Special Plan & Architectural Review Meeting

MEMORANDUM

Re: Site Plan Review and Certified Survey Map

ONSITE CIVIL ENGINEERING INFRASTRUCTURE PLANS

SITE PLAN

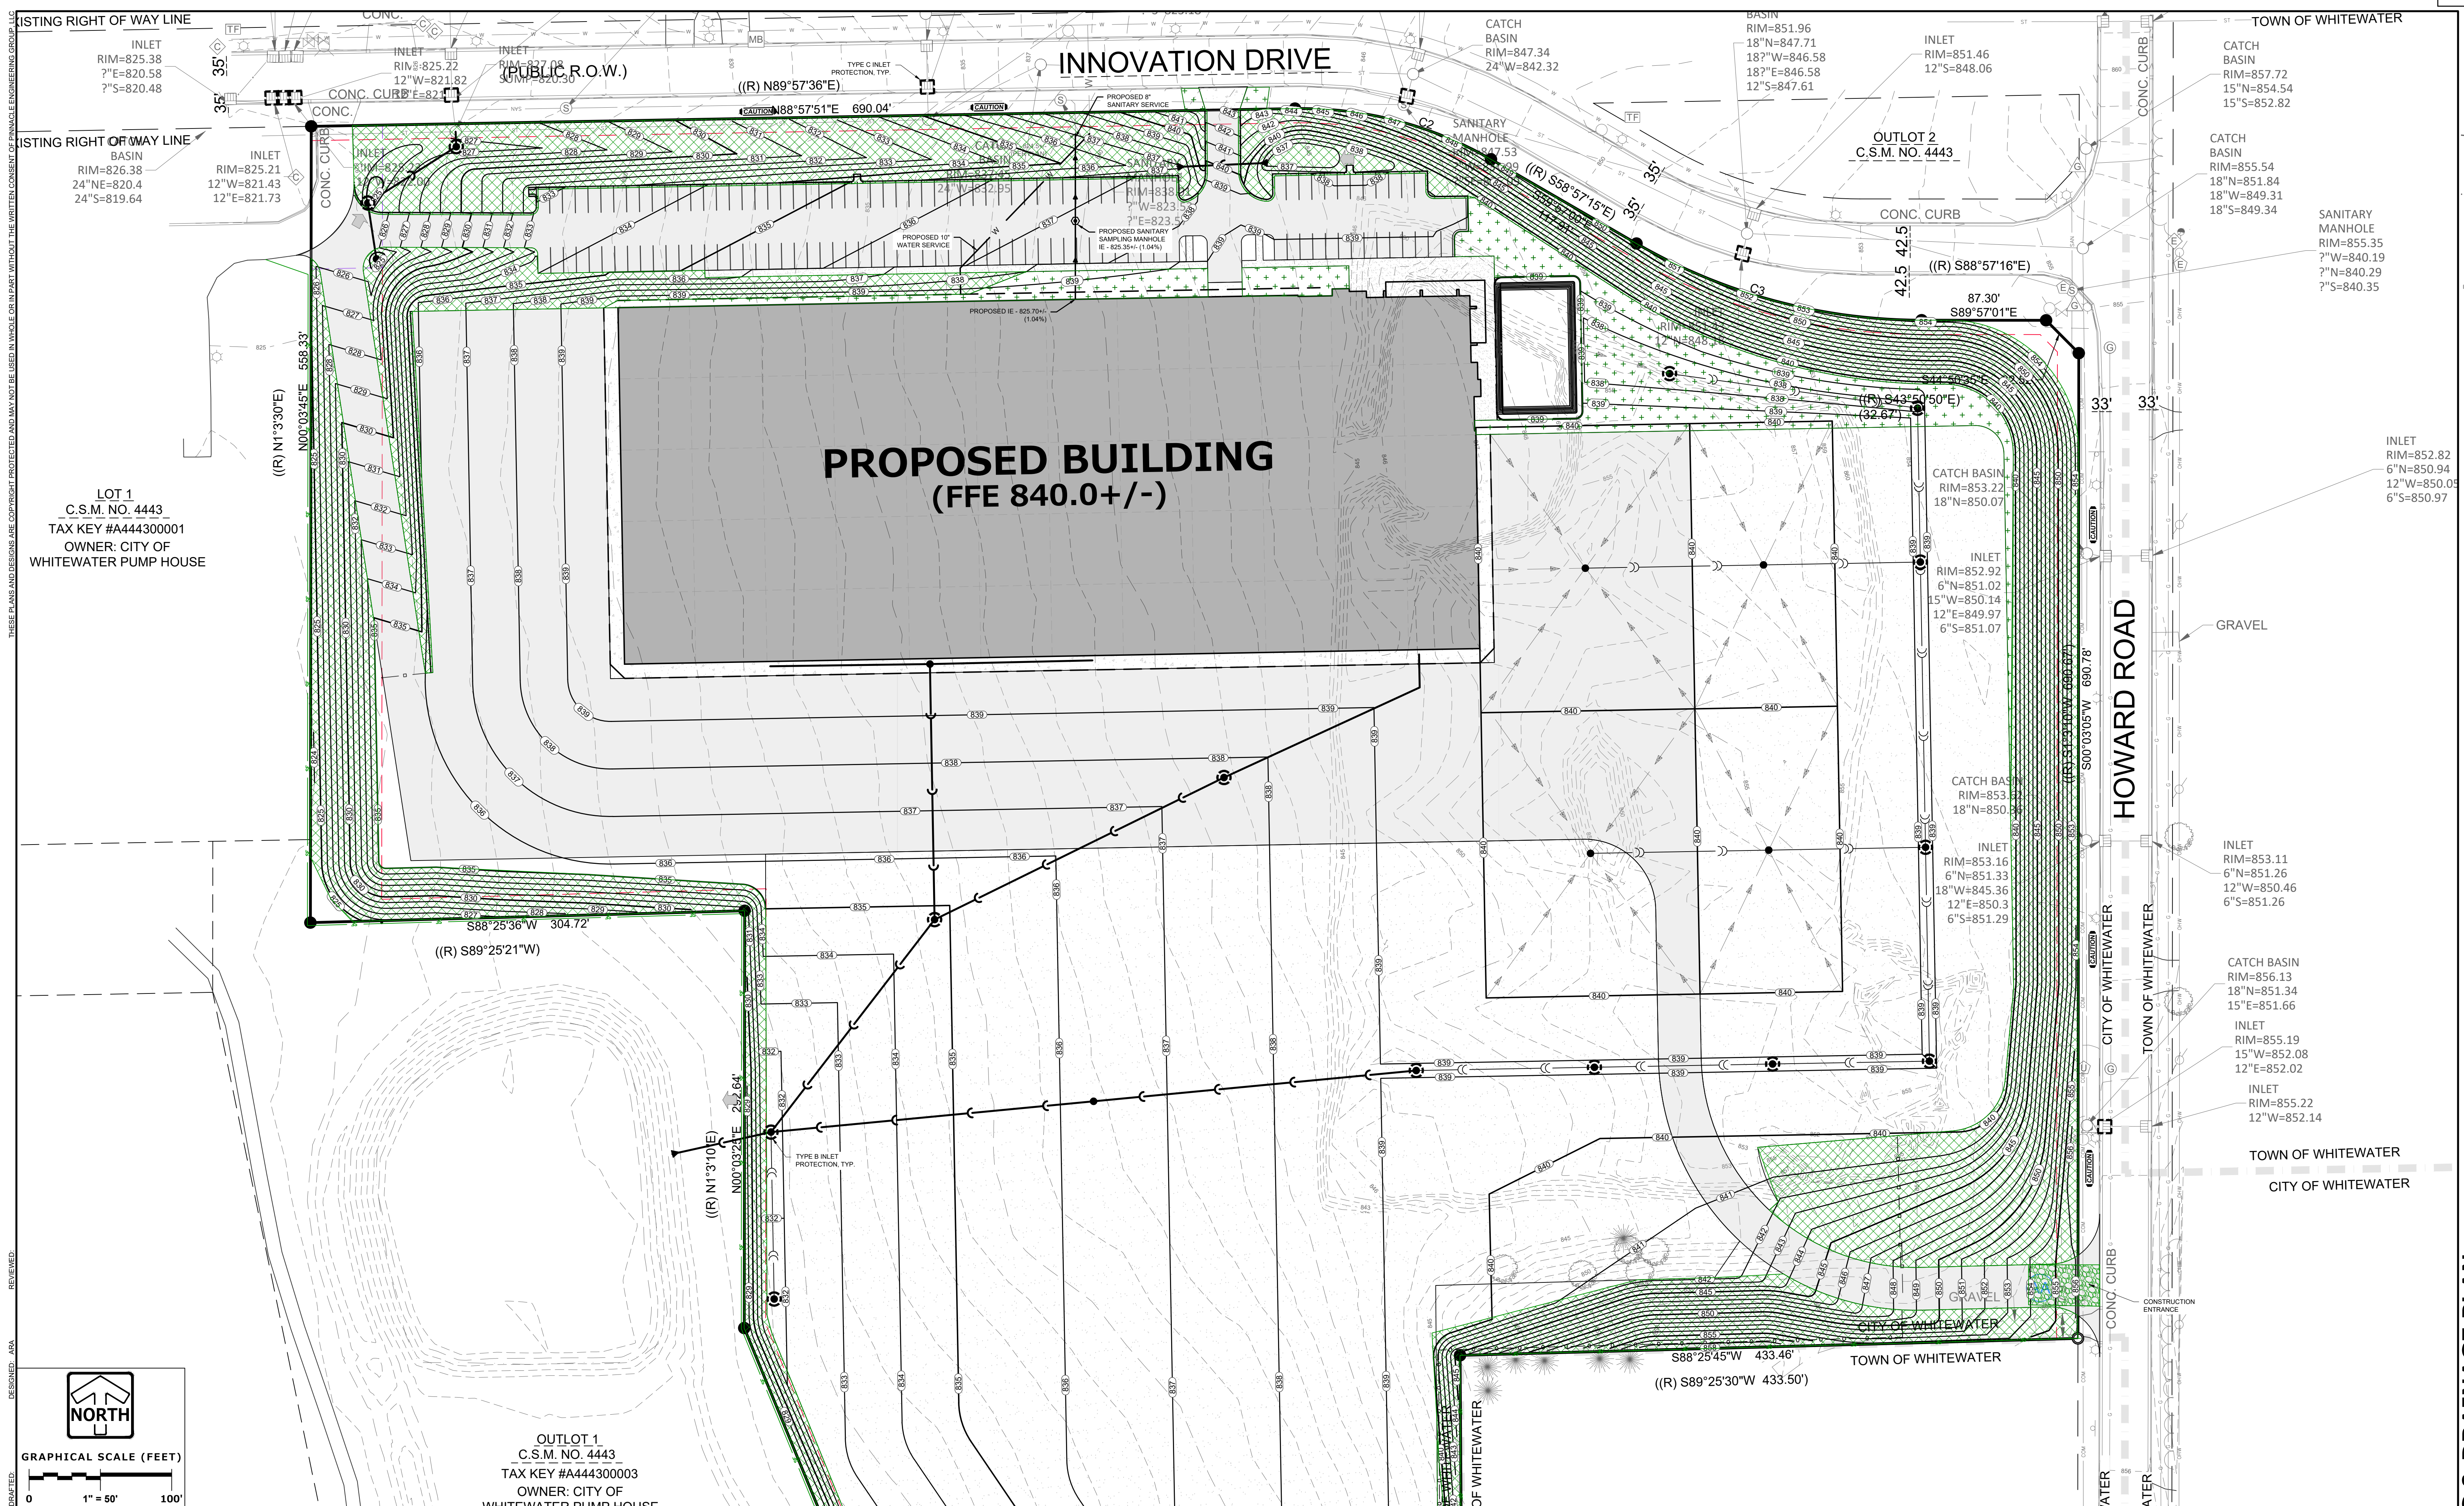
The proposed plans comply with all setback requirements set forth in the zoning district, however, will require exemption to 4(a), as two driveways are proposed off Innovation Drive. Given the scale of the project two access points have been deemed appropriate.

4. Accessory Off-Street Parking and Loading. Accessory off-street parking lots, loading berths, and access driveways shall be located, designed and improved so as to provide for safe and convenient access from adjoining streets, safe and convenient circulation within the site, and an aesthetically pleasing site design. Parking lots and access driveways shall be designed and located so that such facilities do not provide a direct unlandscaped view from the street to the parking lot or access driveway. **The proposed parking area is proposed to be placed between the building and Innovation Drive. However, the landscaping plans show proposed landscaping between the parking lot and Innovation Drive.**

LANDSCAPE OVERVIEW & TREE PLAN

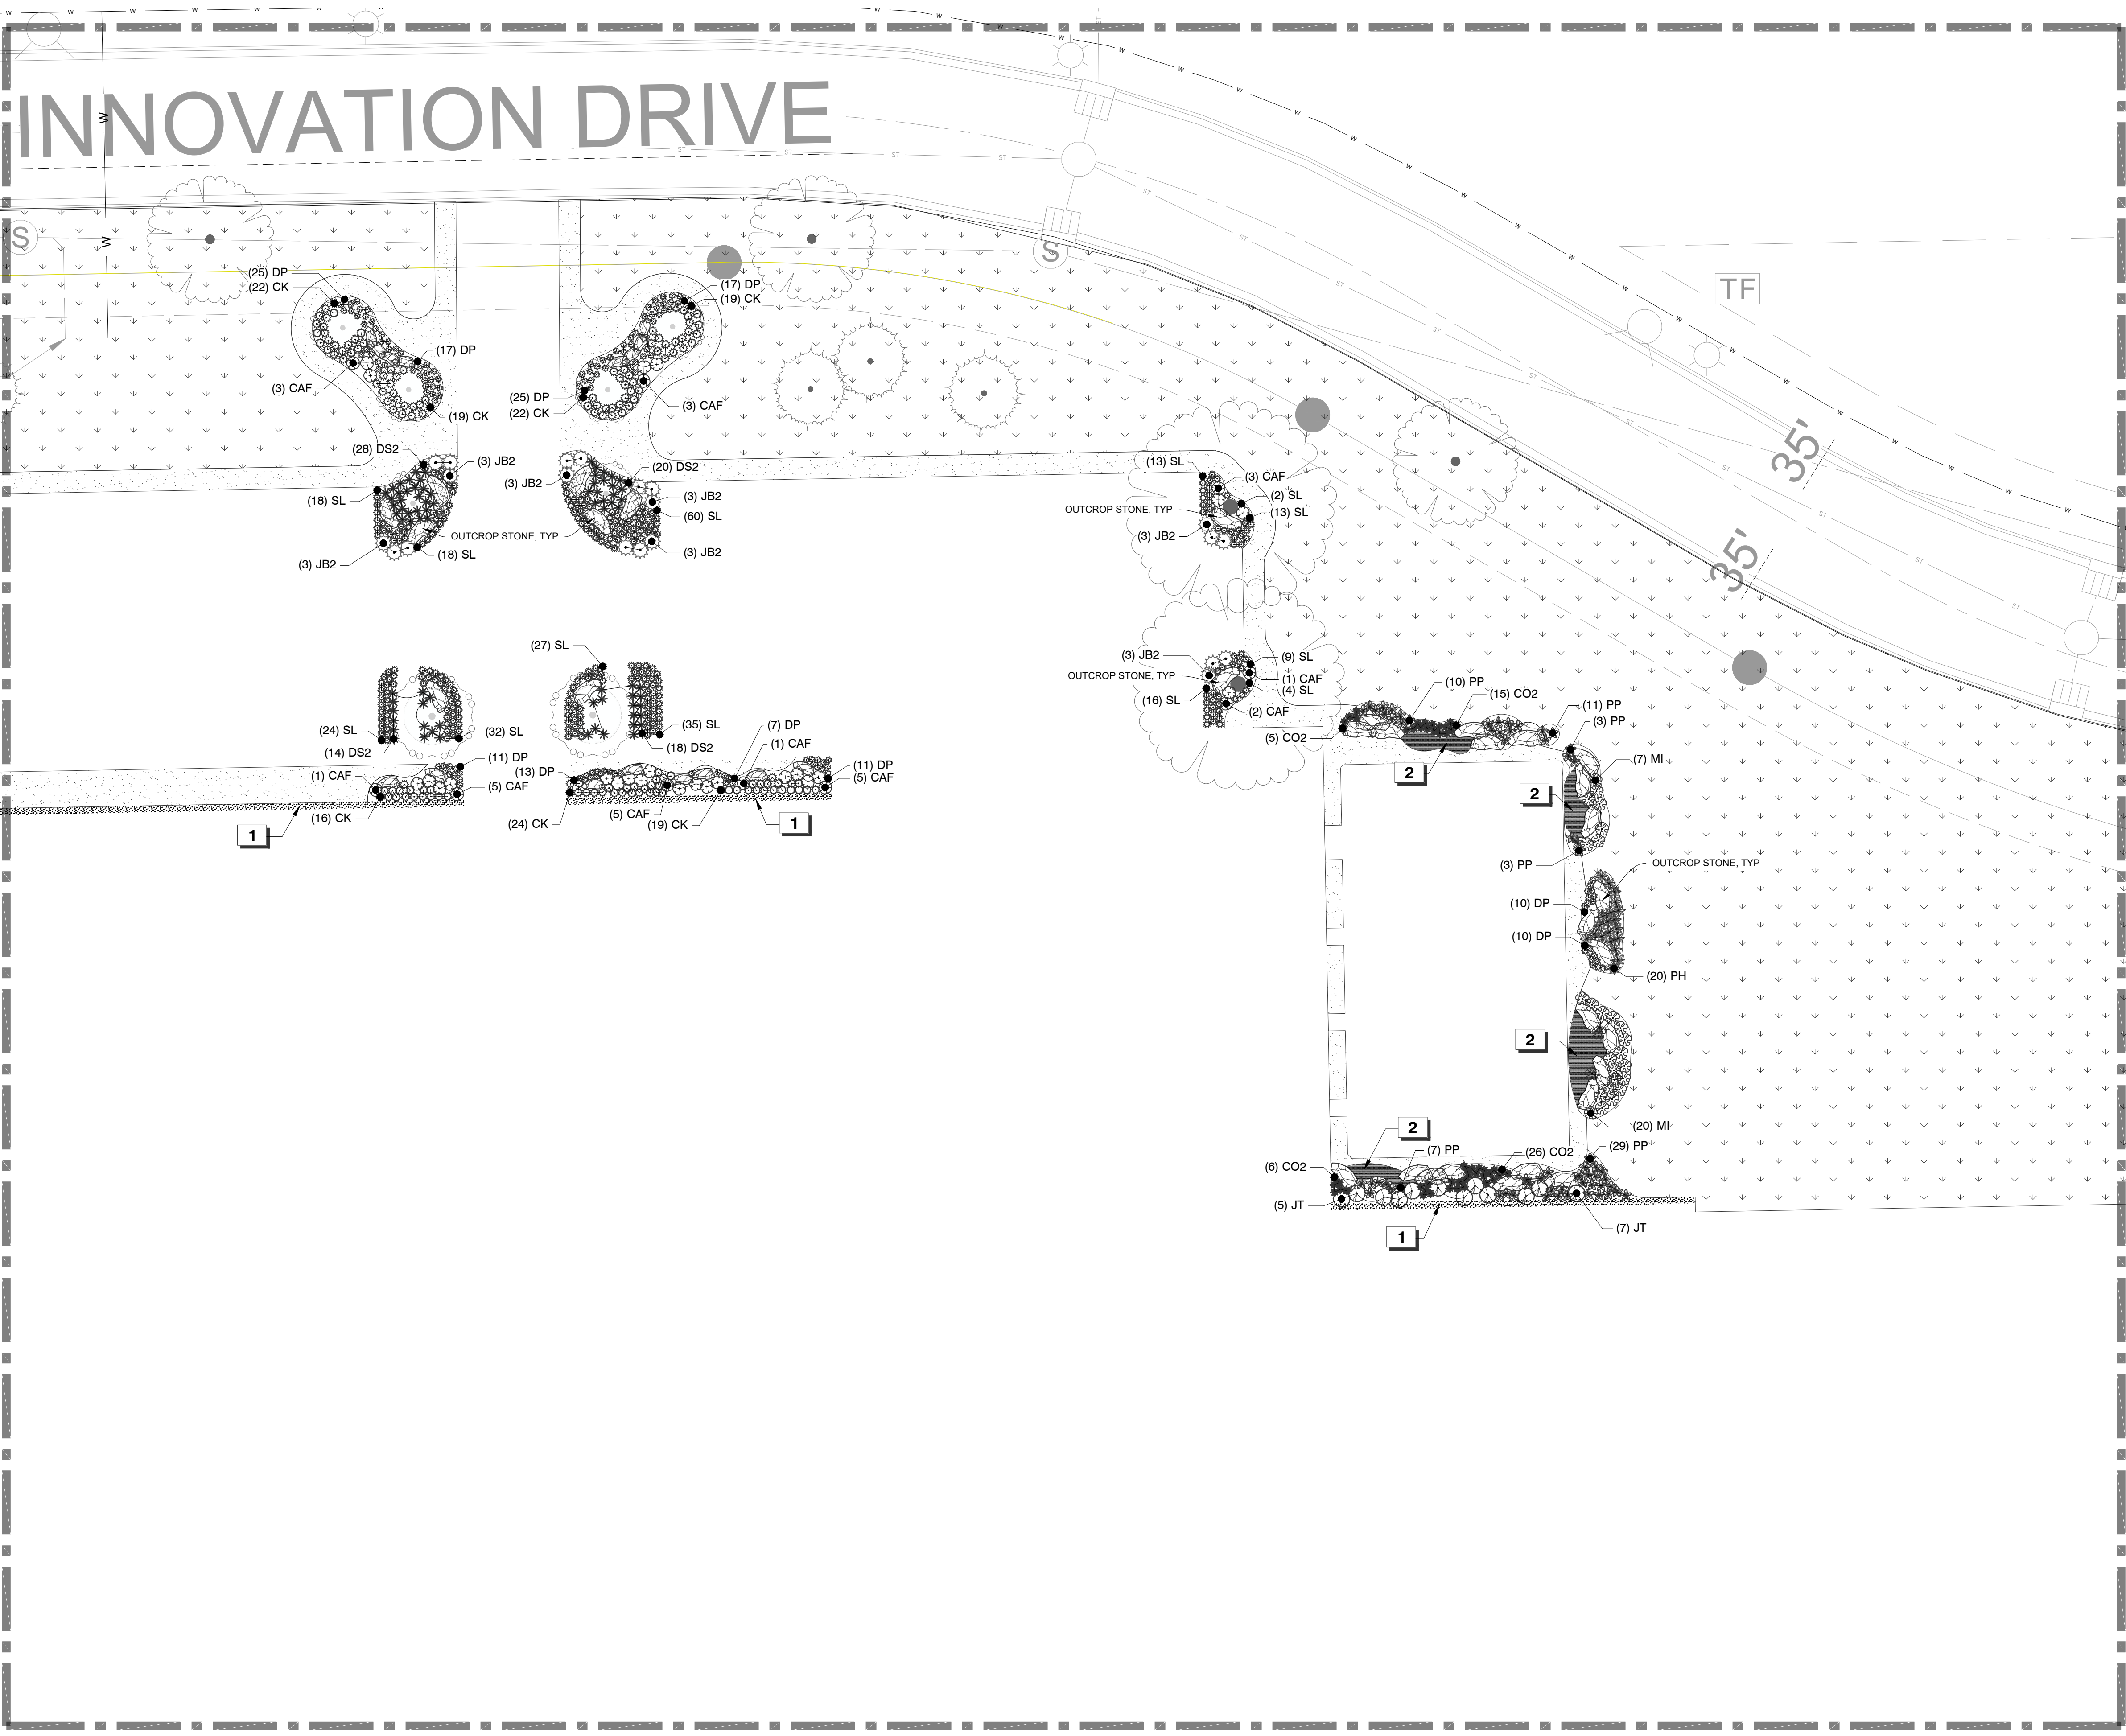
5. Landscaping and Site Development. To provide a park-like setting, all lots shall be landscaped, including the provision of canopy-type shade trees. When adjacent, connected, or within thirty feet of an environmental corridor or environmental corridor buffer, all existing mature, healthy trees shall be retained and protected, where possible, during construction as per city of Whitewater forestry guidelines. All land areas not covered by buildings, structures, storage areas, parking lots, loading areas and driveways shall be landscaped and maintained. Landscaping shall mean decorative plazas, mounds, environmental preserves, enhancements of wetlands, stormwater features designed as landscape enhancements, features incorporated into the landscape for the purpose of improving sustainability of the site, pools or the planting of grass, shrubs, trees and other plant materials or other comparable surface cover. Use of bioswales, rain gardens, prairie plantings in lieu of lawn, and native planting solutions are encouraged. Decorative berms with organic shapes are encouraged, rather than more rigid, angular, or straight berm designs. Wherever possible, ponds, wetlands, and/or storm water detention and/or retention basins should be intentionally designed to provide an aesthetic element to the site. **Landscape plans will be reviewed by Urban Forestry, and plans shall be contingent upon their approval.**

- 1) Staff recommends the plan commission **APPROVE** the Site Plan Review and One Lot Certified Survey Map with the following conditions:
 - Landscaping plans shall be reviewed and approved by Urban Forestry.
